ADVISORY
BULLETIN

No. 2001-09
(Mercury Jet Drives No. 2001-01)

Official Recall Notification Federal Boat Safety Act Voltage Regulator – 240 HP Jet Drive

240HP JET DRIVES – 2000/2001 Model year product

- a** - Voltage Regulators
- b** - Fuse Holder

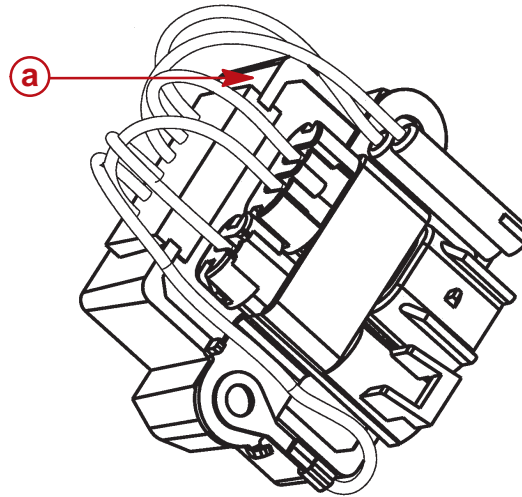
In November of 2000, a field campaign was initiated for all 240HP Jet Drives with the serial numbers 0E370718 through 0E394131. The campaign required the replacement of the voltage regulators. However, Mercury Marine has recently learned that the potential for a short, although very remote, still exists in the replacement voltage regulators. This risk can be eliminated by increasing the rating of the fuses from 20A to 30A.

- All 240HP Jet Drives that did not respond to the original field campaign will require both the regulators and fuses replaced (serial number 0E370718 – 0E394131).
- All 240HP Jet Drives that did respond to the original field campaign and those with serial numbers 0E394132 through 0E397308 will require only the fuses replaced.

a - Location of Dot

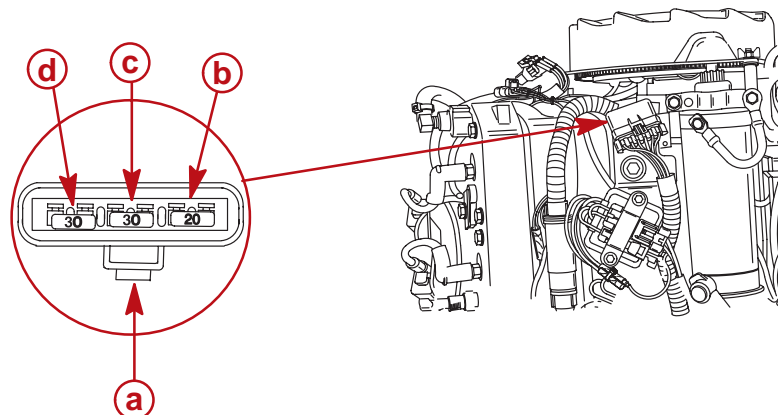
All boats in inventory (new or used) with 240HP Jet Drives that fall in the affected serial number range should be checked. Inspect the regulators for either a “Green” or “White” dot and/or part number (883072-1) stamped on them. Painted dots are located next to the wires exiting the regulator. The part number is located on the opposite side of where the wires exit the regulator. Also, check the fuses. If they are 20A fuses, replace with 30A as shown below.

- a** - Position Fuse Holder with Clip Facing Down
- b** - 20 Amp Fuse - Accessories and Starting Circuit
- c** - 30 Amp Fuse - Top Mounted Regulator
- d** - 30 Amp Fuse - Bottom Mounted Regulator
